## Clarification# 1 against Tender# PROC-SERVICES/CB/P&amp;P-4756/2020

**OIL & GAS DEVELOPMENT COMPANY LIMITED**  
**UCH-I GAS PROCESSING PLANT - ATA 2020**  
**(PSVs Sizes, Ratings and Set Points)**

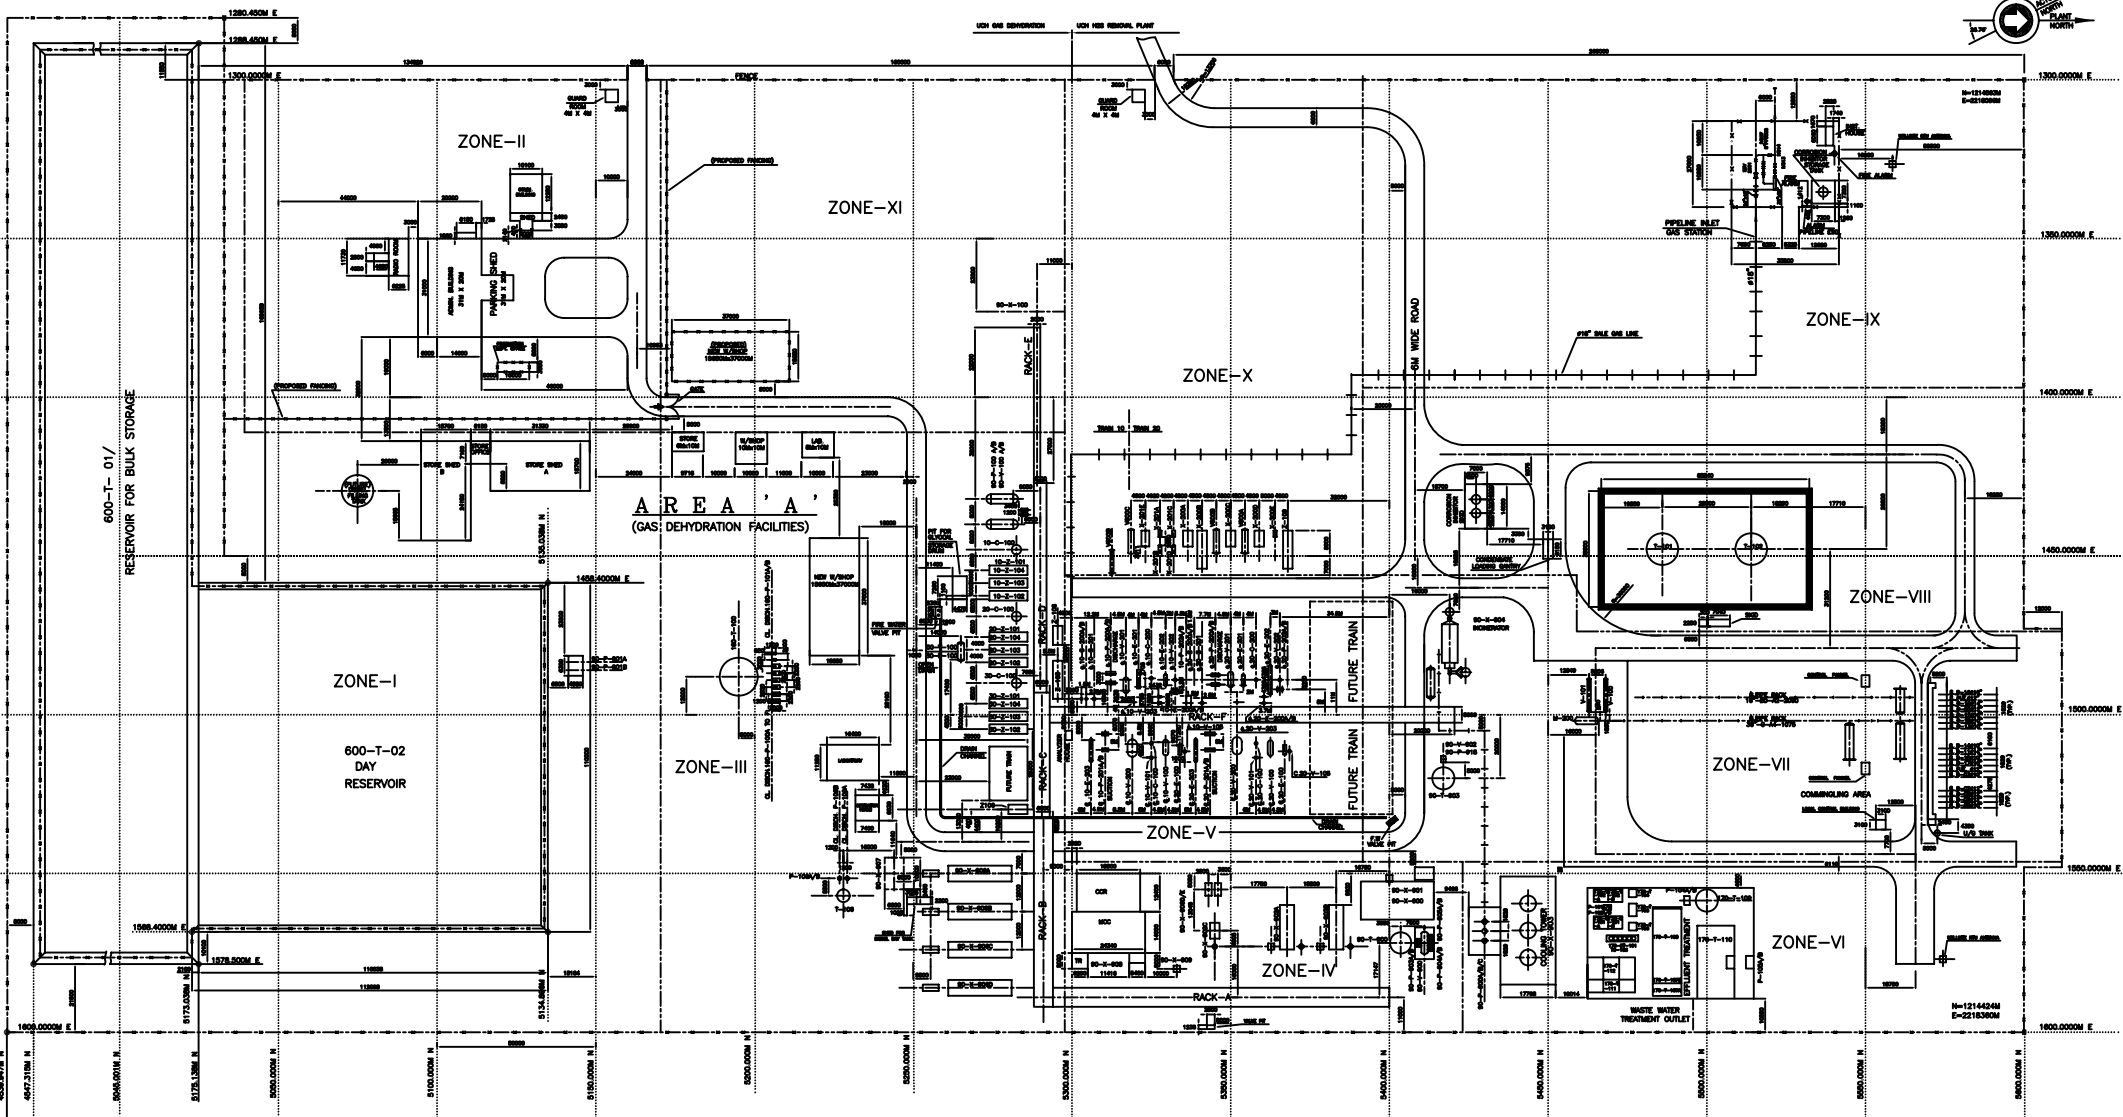
4	Is excavation required for any piping or equipment work and who will be responsible to perform it contractor or OGDCL	No excavation work included in SOW
5	Please provide us the plot plan of UCH Gas -1 plant that will assist us to calculate exact resources / equipment's	Plot Plan is attached
6	As per our understanding, Compressed air for ventilation of columns, electricity for for welding plants and for stress relieving machines & water for jetting will be provided by OGDCL. Please confirm.	Electricity and water shall be provided by OGDCL but for ventilation and filters cleaning etc. as per SOW, Contractor will have to arrange air compressors accordingly.
7	Please confirm whether valid card holder welders are acceptable to OGDCL. If not, for welders qualification tests, test pieces & consumables will be provided by OGDCL. Kindly confirm.	3rd Party Valid Card Holder Welders are acceptable to OGDCL. In case of welder qualification test, OGDCL will provide test piece & consumable will be contractor responsibility
